Access Compliance Report

Public Rights-of-Way

(Curb Ramps)

Intersection ID: 42714	Main Street: ARBORETUM_DR	Cross Street: PROVIDENCE_RD	Location: NE
ADA ID: 36272F4FD143	Ramp Type: MedianPerp	Initial Pass/Fail: Fail	Overall Compliance: No
Severity Score: 13.75			
Codes/Mitigation Info/Possible Solution		Field Measurements/Component Compliance

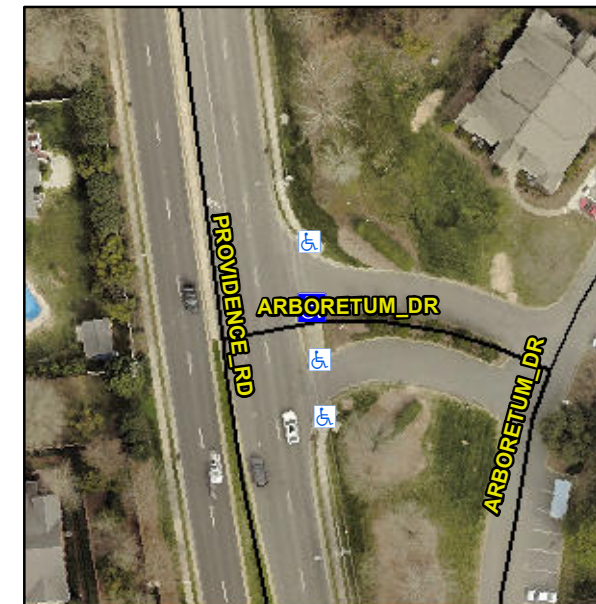
Not Found, R304.2.2, R304.5.3

Compliance	Description	Data	Compliance	Description	Data
N/A	Ramp Length (in)	46.5	No	Ramp Slope (%)	9.3
Yes	Ramp Width (in)	48.0	No	Ramp XSlope (%)	3.5
N/A	Flare Type LT	N/A	N/A	Flare Type RT	N/A
N/A	Flare Slope LT (%)	N/A	N/A	Flare Slope RT (%)	N/A
N/A	Flare Traversable LT?	N/A	N/A	Flare Traversable RT?	N/A
N/A	Landing Length (in)	N/A	N/A	DWS Provided?	N/A
N/A	Landing Width (in)	N/A	N/A	DWS Contrast?	N/A
N/A	Landing Slope (%)	N/A	N/A	DWS Length (in)	N/A
N/A	Landing X Slope (%)	N/A	N/A	DWS Full Width?	N/A
N/A	Landing Curb? (Y/N)	N/A	N/A	DWS Offset (in)	N/A
N/A	Shared Landing?	N/A			
N/A	Gutter Ponding?	N/A	N/A	Gutter Slope (%)	N/A
N/A	Gutter Lip Ht (in)	N/A	N/A	Gutter X Slope (%)	N/A
N/A	Painted X Walk1?	No	N/A	Painted X Walk2?	N/A
	X Walk 1 Direction	To N		X Walk 2 Direction	N/A
N/A	X Walk 1 Width (in)	N/A	N/A	X Walk 2 Width (in)	N/A
	X Walk 1 Slope (%)	0.3		X Walk 2 Slope (%)	N/A
	X Walk 1 X Slope (%)	1.3		X Walk 2 X Slope (%)	N/A

Remove & Replace Entire Ramp.
